DESCRIPTIVE REPORT

Field No. **Gi-1255** ..... Office No. **H-8207**

Locality ..... FALL RIVER HARBOR

REVIEW OF HYDROGRAPHIC SURVEY

OVERLAY FOR  
G1 25/155

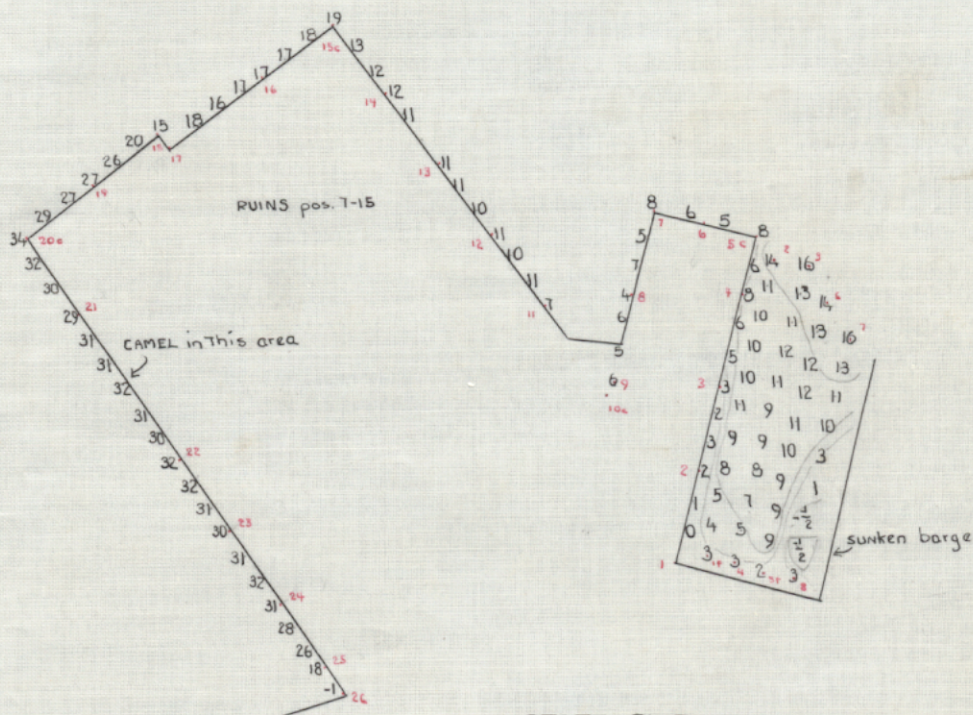
soundings from Vol. 5  
around pier - pgs. 36-37  
in slip - pgs. 50-51

*cht. 353 - no correction*
